Public Comment re MIRP

MIRP Impact
on
Water Quality
in
Gashouse Cove

July 2026

Figure 25 Permeable Reactive Barrier profile on West border

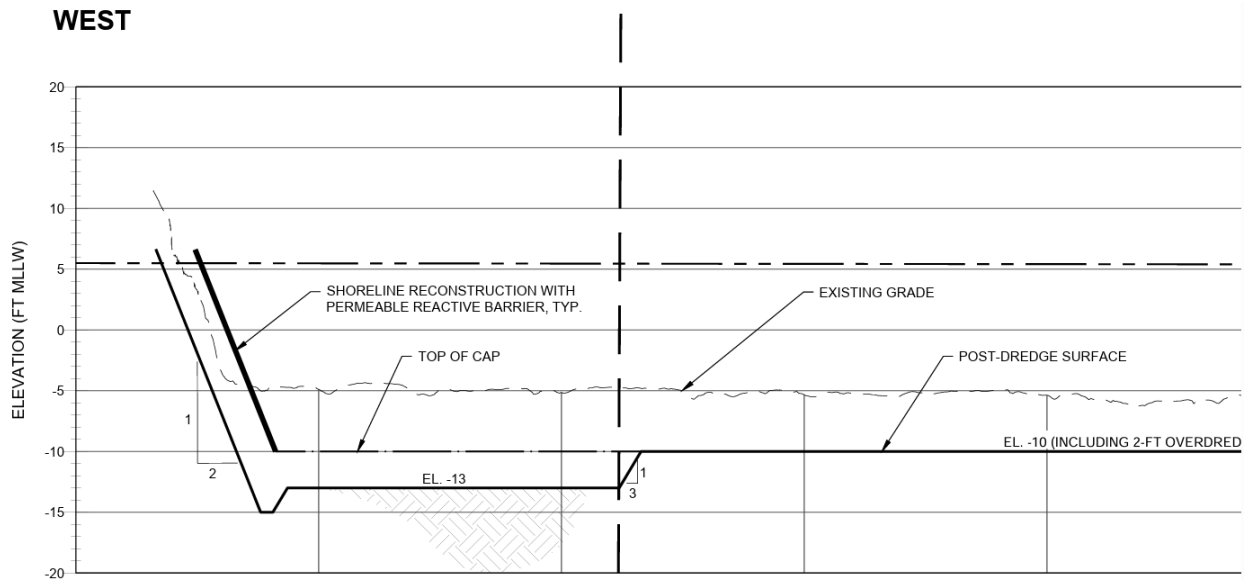
As shown in Figures 24 and 25, the MIRP will install a permeable reactive barrier on Gashouse Cove's west and south shorelines. Unlike *low* permeable barriers used in engineered caps and IRM, which are designed to block water along with everything else, permeable barriers are designed to allow water to pass while blocking NAPL.

Similar to the IRM's reactive core mat – the remediation measure that failed – permeable reactive barriers are essentially large flat filters consisting of a layer of activated carbon sandwiched between two layers of cloth. Activated carbon is supposed to be good at absorbing NAPL, but NAPL in groundwater is evidently better at finding a pathway into the water column. That's why the IRM failed. It's possible there was so much NAPL exiting the seep that the filter quickly absorbed all the NAPL it could and the rest simply flowed through it or around it. This begs the question of replacement.

The important aspect of MIRP's plan for a permeable reactive barrier, however, has not been discussed. It is that this 'additional measure of protection' is focused solely on the shoreline and ignores the bottom. There are large quantities on chemicals distributed heterogeneously under the sediment.²² Because Gashouse Cove was dredged when the boat harbor was built, the depth of these chemicals is 8' MLLW and below:

Figure 26 Illustration of chemicals below sediment

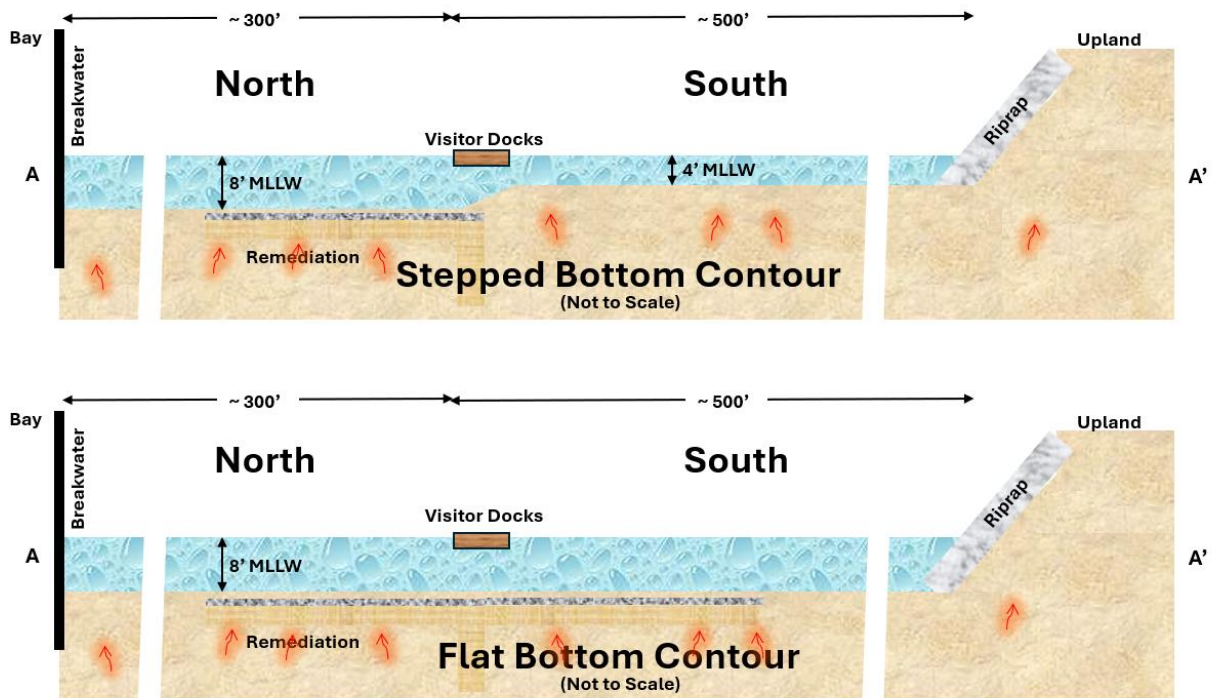
Figure 26 illustrates the potential for chemical seeps for the stepped bottom and the flat bottom options. In areas not dredged, the 8' MLLW ceiling for the chemicals means there are several feet of uncontaminated sediment above the chemicals. The engineered cap for the dredged areas is still being designed. It may consist of a chemical isolation layer similar to the permeable reactive barrier or a low permeable barrier similar to the backfill in the IRM. Either choice presents the same difficulties as above. The bottom line is that, as with the shoreline, there are barriers that have a chance of constraining NAPL but there is nothing that will inhibit the interchange of porewater under the sediment with surface water in Gashouse Cove.
